PROJECT AREA 2 SUMMARY REPORT (from E14th St to E23rd St)

COMMUNITY ENGAGEMENT SESSIONS: DESIGN ALTERNATIVES

ALTERNATIVE A

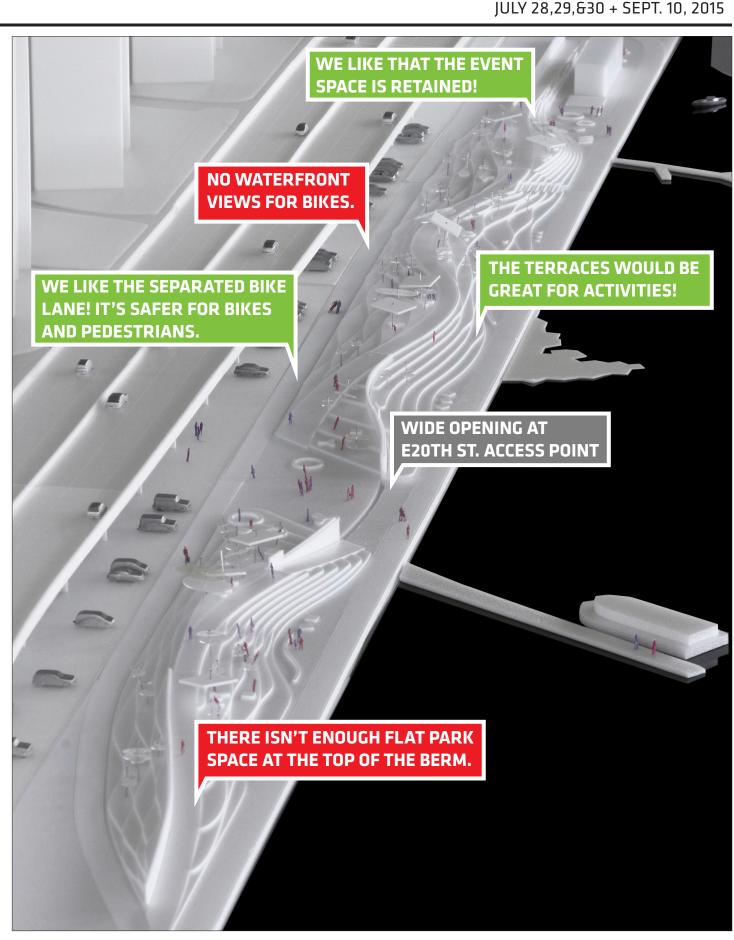
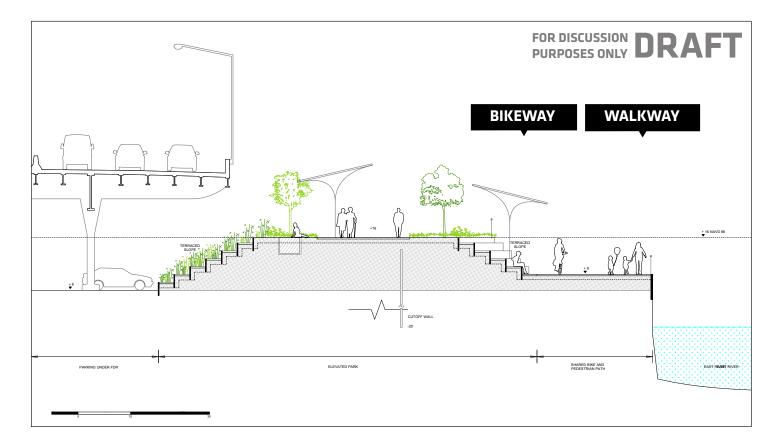
- While a majority of workshop participants appreciated the separation between the pedestrian walkway along the waterfront and the bikepath on the western edge of Stuyvesant Cove Park, several groups pointed out that bikers would be hidden behind the berm, unable to benefit from waterfront views.

- Many participants voiced concerns about the limited amount of usable park space at the top of the berm.
- Participants were pleased to see that the event space near Solar Two would be maintained and several groups inquired about whether the building would flood in this configuration. If built at grade, Solar Two's first floor would be designated a floodable space, while all occupied spaces would be located on the second floor, above the design flood elevation.

- Participants embraced the idea of a wide opening that would retain view corridors from further up E20th St. and facilitate circulation flows from and to the future ferry terminal. Several individuals inquired about the look and feel of the berm, particularly as it transitions into the flood gate at E20th St.

ALTERNATIVE B

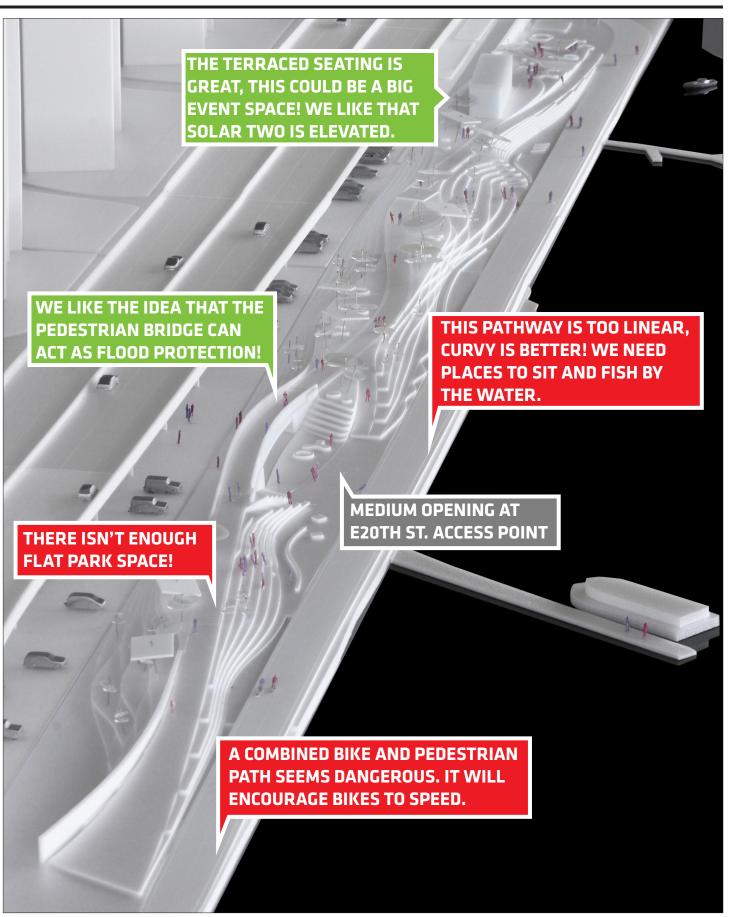
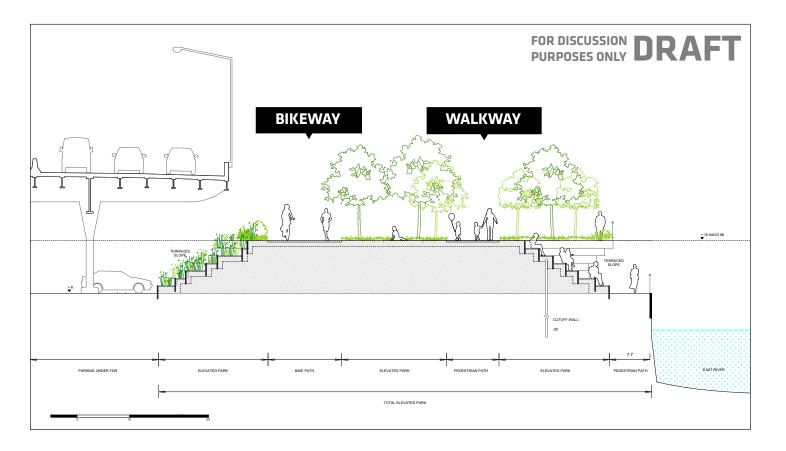
- For safety reasons, participants were highly concerned about the combined bike path and pedestrian walkway along the waterfront. Many pointed out that the linear geometry would encourage bikes to speed, potentially creating collision hazards since the waterfront should also accommodate pedestrians, runners, and fishermen amongst others.

- There was a strong preference for a meandering pathway along the waterfront, with vegetated pockets and benches facing the water.
- While participants found the idea of walking on top of the berm appealing, many stressed that this alternative would not provide enough usable park space.

- The elevated Solar Two structure was well received by workshop participants. Several individuals pointed out that vehicular access to the building would be beneficial.

- All groups emphasized the need for a large event space in the park, with a capacity of up to 100 guests. Participants expressed enthusiasm about the amphitheater-like seating near the E20th St. opening and the terraced seating in proximity to Solar Two.

ALTERNATIVE C

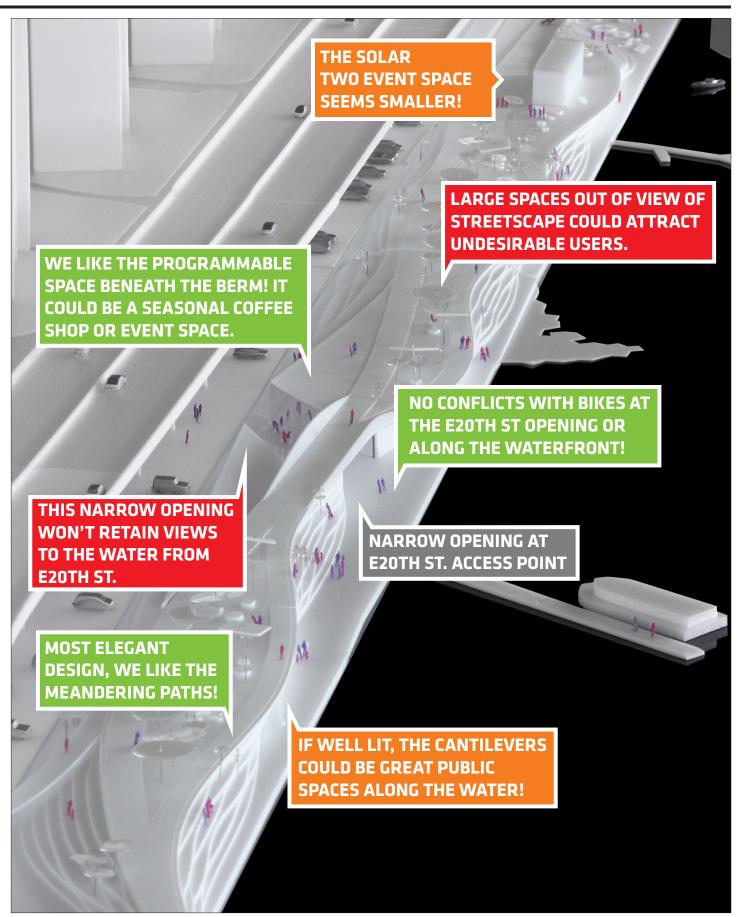
- Participants were strongly in favor of the flexible programming space beneath the berm at the E20th St. opening. While some saw an opportunity to integrate a seasonal coffee shop, others suggested the indoor space could be used to host events, potentially in collaboration with Solar Two. With increased pedestrian activity and adequate lighting, the access route to the park would remain safe and inviting to all.

- Participants who were particularly concerned about bike and pedestrian conflicts along the waterfront were comforted by the fully elevated bikeway and the two levels of pedestrian pathways. While there was a strong desire to make use of different surface treatments and greenery to clearly differentiate the bike lane and pedestrian pathway, a majority of participants were enthusiastic about this pathway configuration.

- All groups appreciated the wide meandering waterfront path, and many thought Option C provided the most elegant and functional design.
- Several individuals inquired about the slope of the access ramps to the elevated park for visitors with limited physical ability, or strollers.
